INC. VILLAGE OF FREEPORT

March 12, 2024
LETTER OF DENIAL

RE: 16 Archer St, Freeport, NY 11520

Description: Proposed new (4,020 Sq.Ft) wood frame with vinyl siding 2-Story 2-Family residence to existing vacant lot.

DRAWING NO. **T-1**
PROJECT NO. 1
202324
5

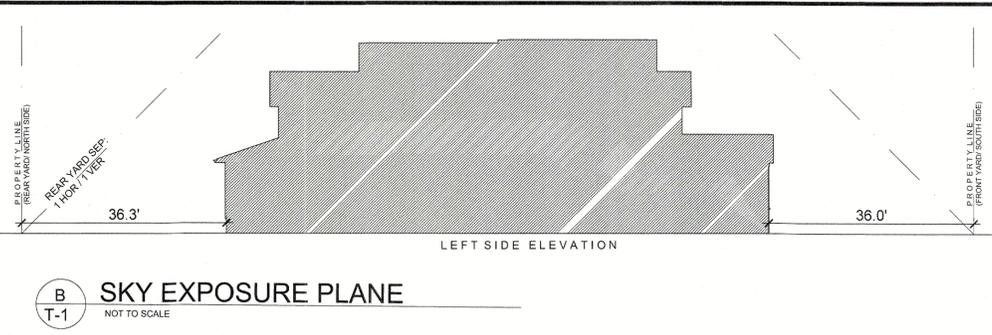
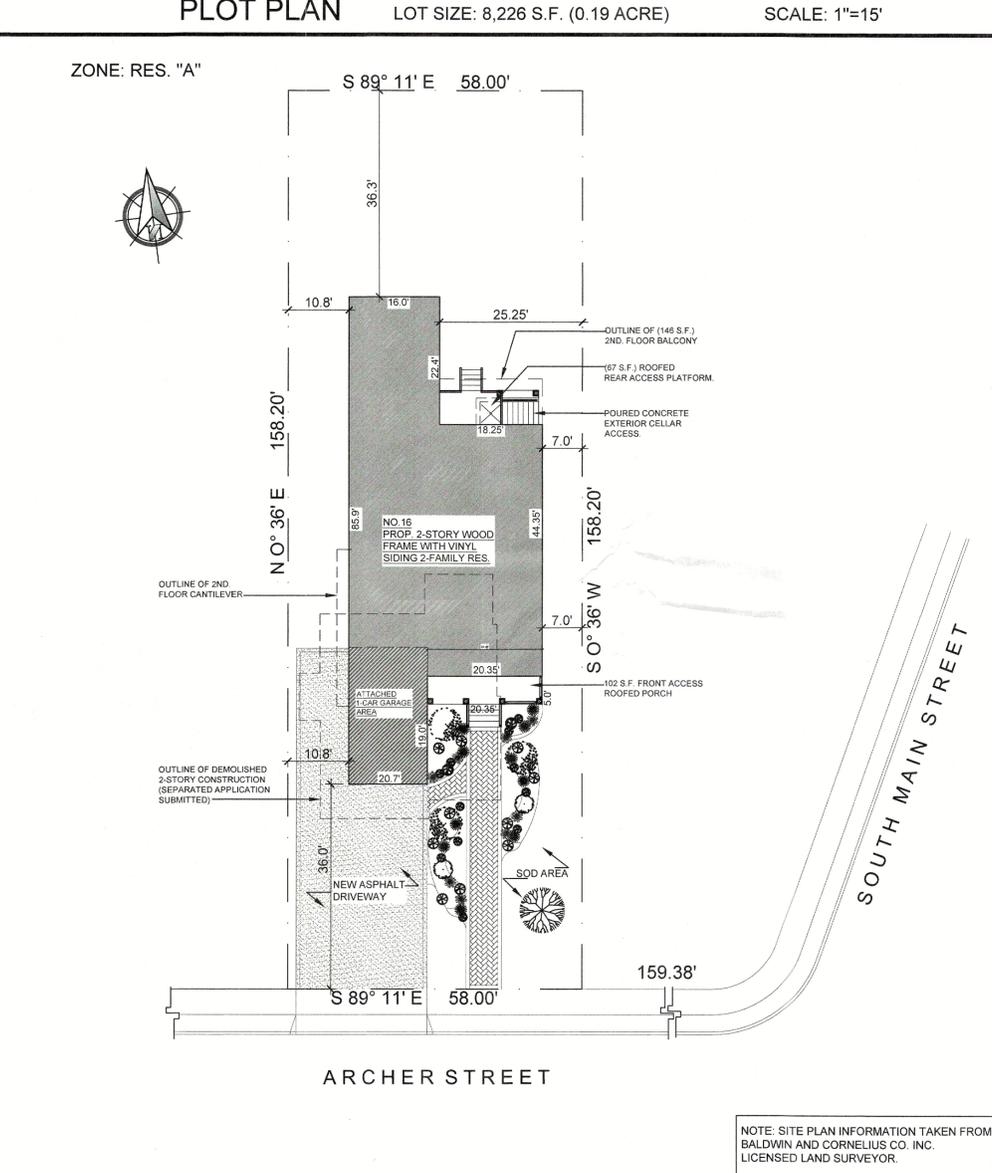
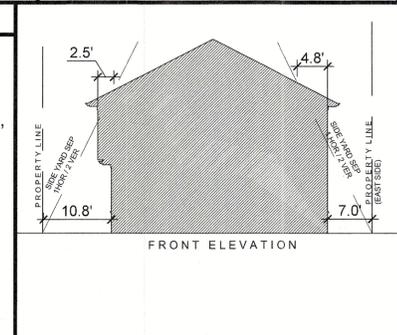
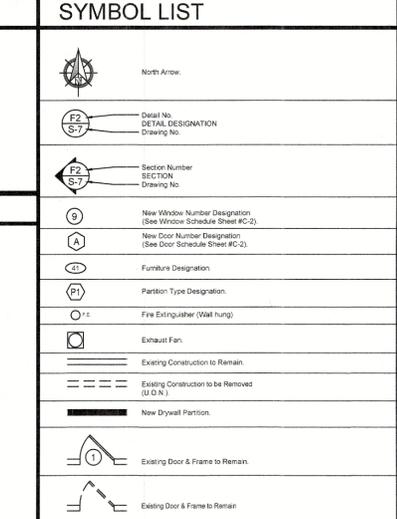
(1) Along front and rear property lines, a SEP pitch of one unit vertical to one unit horizontal. According to the drawings indicate that the sky exposure plan is penetrating the front lines of the property.
